January 9, 1987

Subject: Dresden Station Unit 2
 Systematic Evaluation Program IPSAR
 Topic VII - 1.A; Isolation of the
 Reactor Protection System (RPS) from
 Non-Safety Systems
NRC Docket No. 50-237

C 51301228

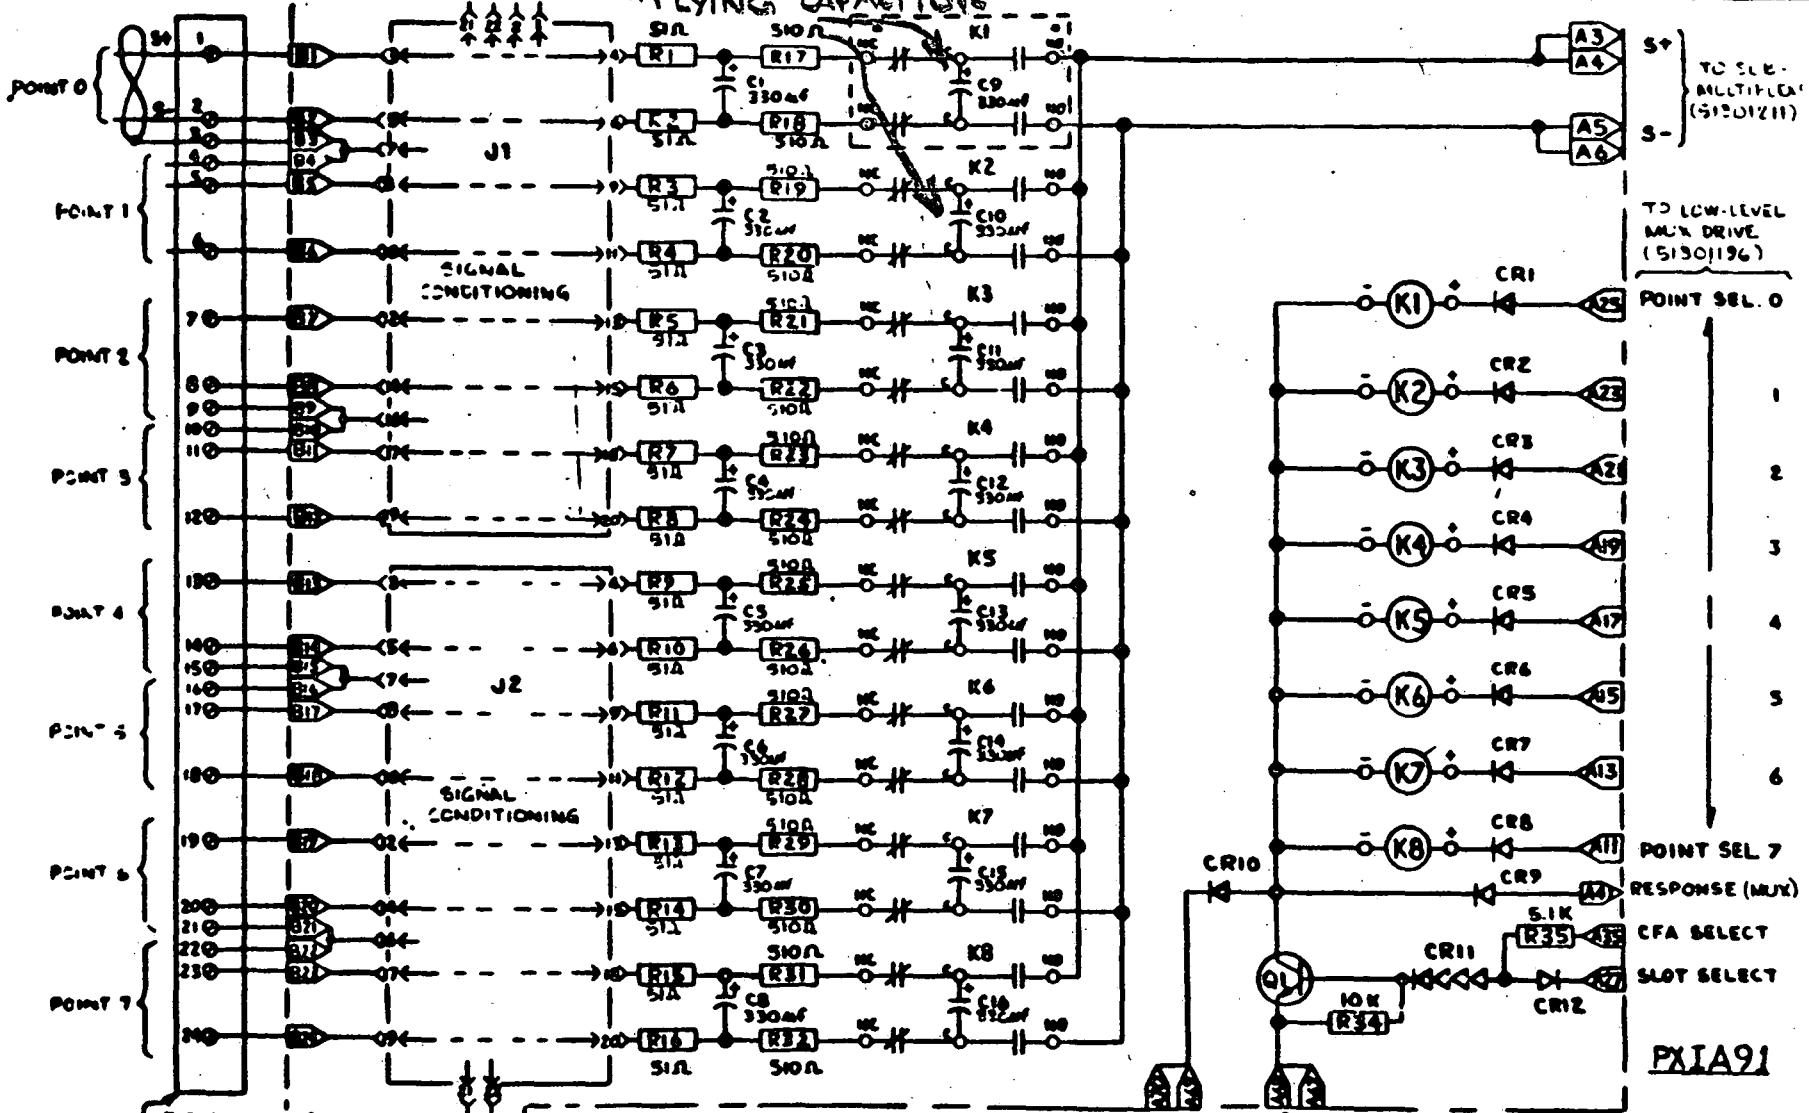
Concern of 4.24.2:

The APRM scram function is derived from relay actuation resulting from amplified analog signals sensed by these relays. The amplified analog signals are input directly to the process computer with fuses as the isolation device. Fuses do not meet the intent of IEEE Std. 279 for isolation devices (e.g. fuses will not isolate ground faults). It is the staff's position that the licensee should address the adequacy of the isolation circuitry to ensure that the RPS is protected from potential common-mode electrical faults that could be propagated from the process computer.

Modifications that have been made to the process computer have included isolation circuitry, sometimes referred to as "flying capacitors", between the computer and the input signals. This scheme will prevent common-mode electrical faults propagating from the computer to the input signals. This arrangement is shown on the attached reference drawing, No. 51301228.
